Procedure Memorandum No. 60

Amending the Guidelines and Standards for Flood Hazard Mapping Partners

Title: Revision to Figure D.2.8-3, Wave Runup Guidance for Vertical Wall, From Shore Protection Manual (USACE, 1984)

Figure D.2.8-3 Wave Runup Guidance from Vertical Wall, From Shore Protection Manual (USACE, 1984)

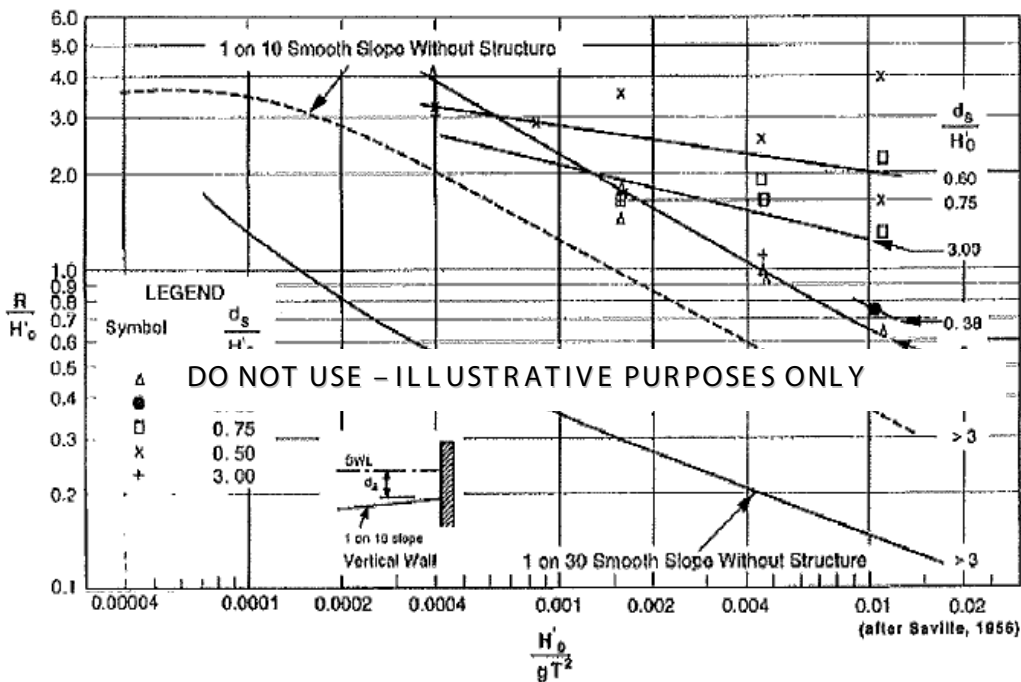
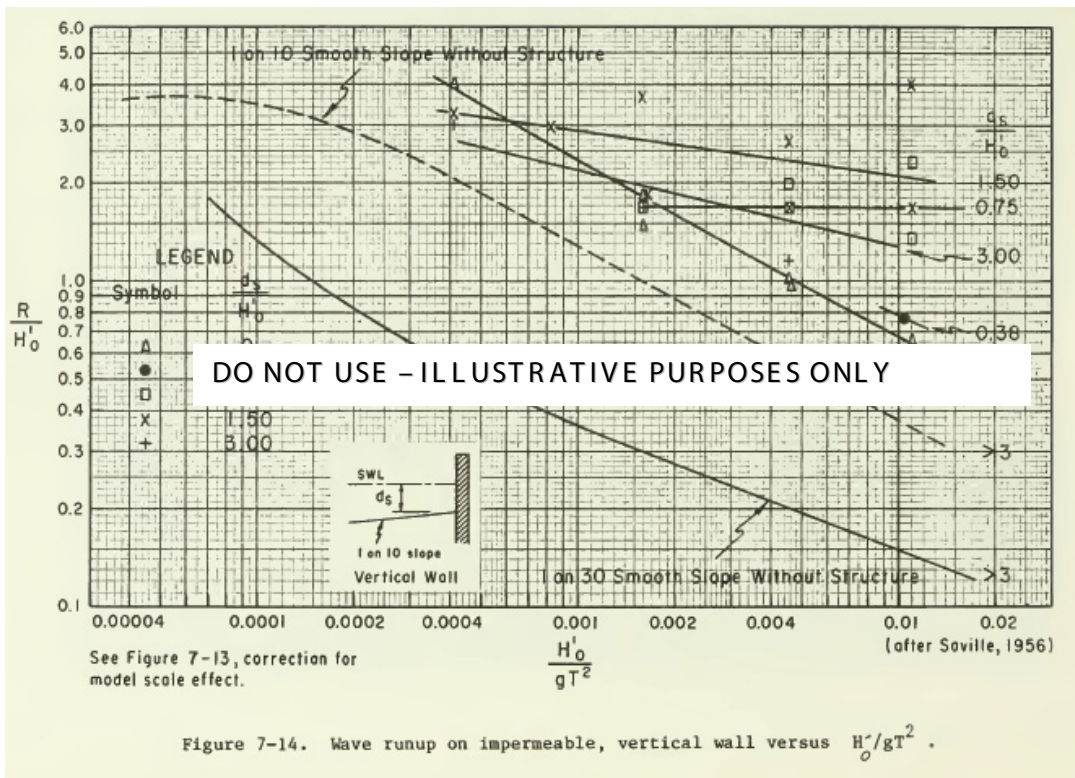
The procedure for estimating wave runup on vertical structures relies on the use of Figure D.2.8-3, shown below, provided the wave steepness and structure depth. The figure cites both the *Shore Protection Manual* (SPM) and Saville's paper (1956). However, a comparison of the *Guidelines'* Figure D.2.8-3 to the SPM's Figure 7-14, also below, revealed an inconsistency in the coefficient for structure depth, d_s/H_0 , listed for the uppermost curve.

The *Guidelines* shows a depth of 0.60 for the topmost curve while the SPM lists the same curve as having a depth of 1.50. The legend of Figure D.2.8-3 of the *Guidelines* also identifies this same curve as having a depth of 0.50. The legend in Figure 7-14 of the SPM again shows a value of 1.50. A review of Saville's work, Fig. 3, below, confirmed the original coefficient published was 1.5.

For all new detailed coastal study starts in Fiscal Year 2010 making use of this procedure for estimating wave runup on vertical structures, the coefficient listed for the uppermost curve is redefined to be 1.50. Letters of map revision submitted for studies initiated or completed prior to issuance of this procedure memorandum shall use the redefined coefficient of 1.50. A corrected Figure D.2.8-3, presented below, contains these changes.

Corrected Figure D.2.8-3:
